Groundwater Transfer Review Summary Form

Transfer/PA # T- 13538

Application: T-13538

Applicant Name: Oregon Water Utilities

Water Level Data from Area Wells

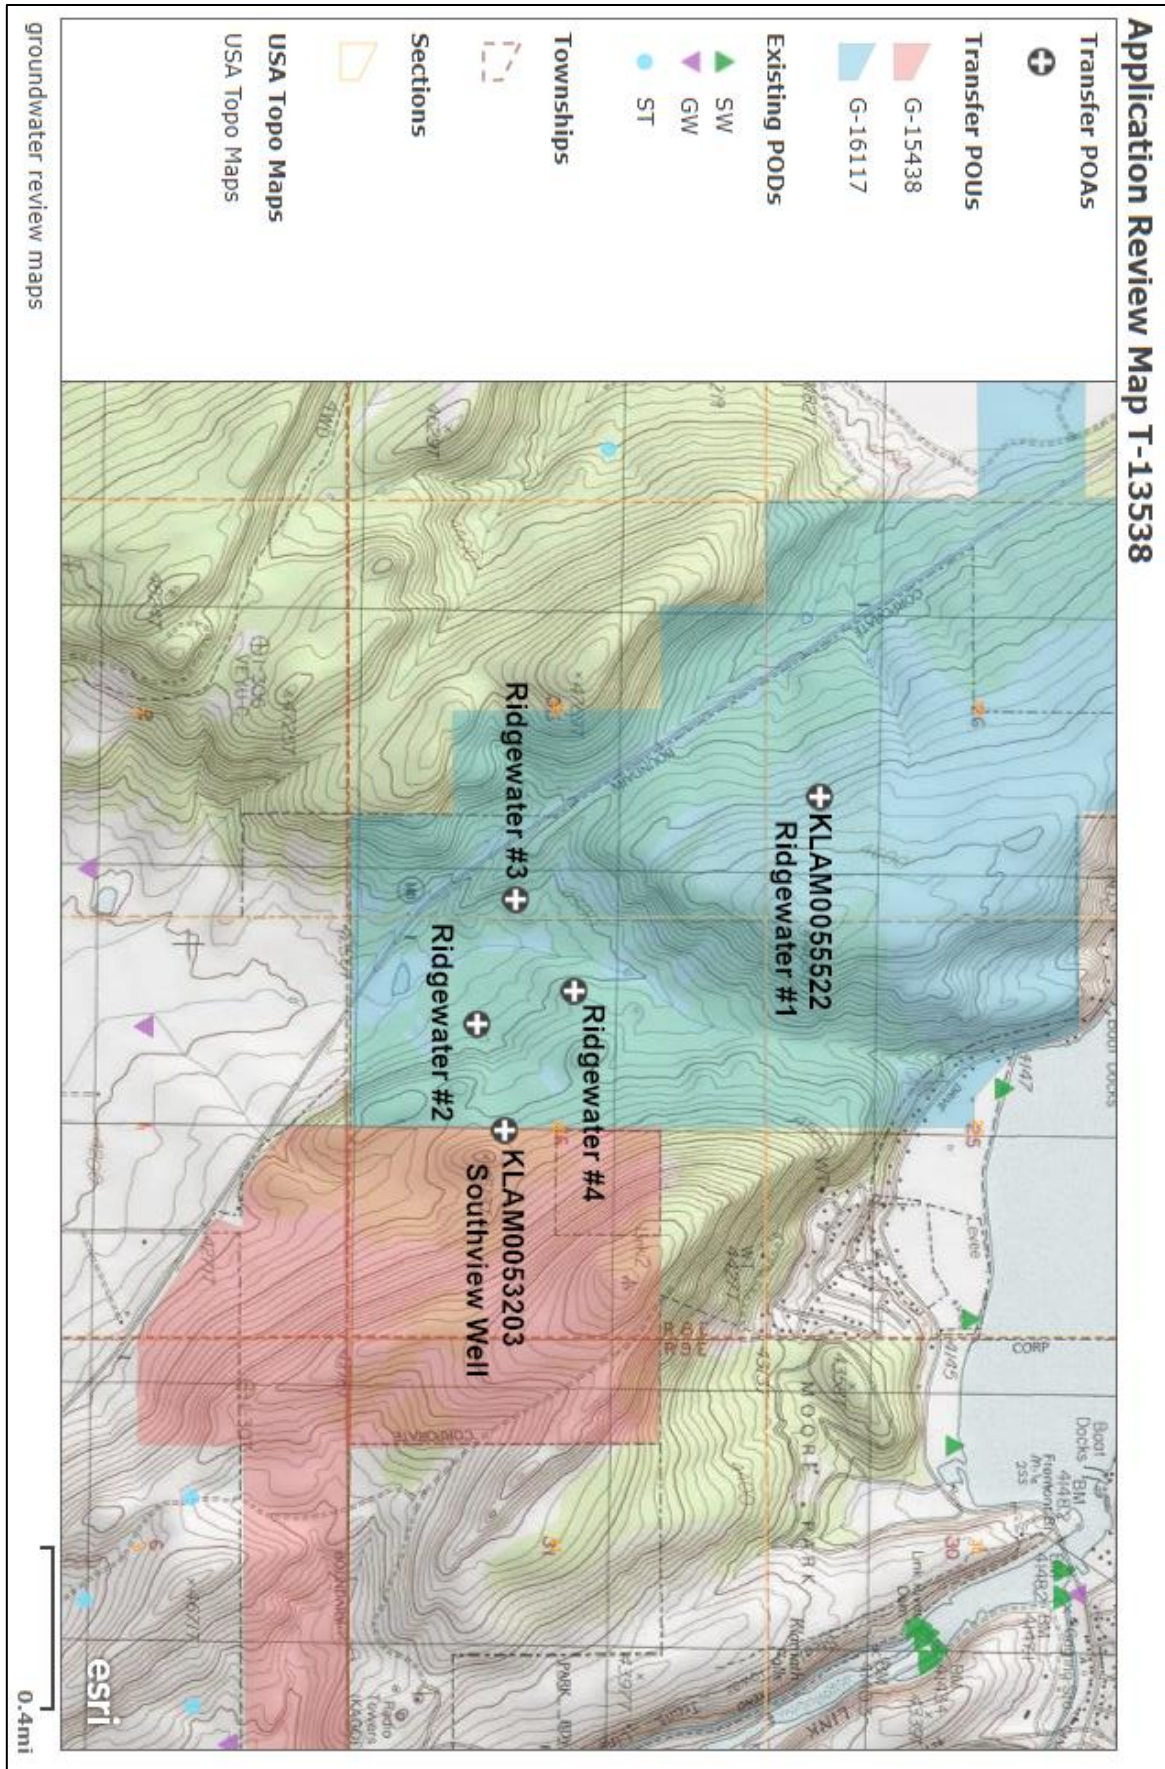
2. Will the proposed POA develop the same aquifer (source) as the existing authorized POA?
 Yes No Comments: Both existing wells (KLAM0053203 and KLAM0055522) are producing from the Tertiary basalt aquifer system underlying the area. The undrilled wells (“Ridgewater” Wells #2, #3, #4), with the proposed construction, would also be producing from the Tertiary basalt aquifer system. Additionally, water-level data is consistent among wells in the area (see figure below).
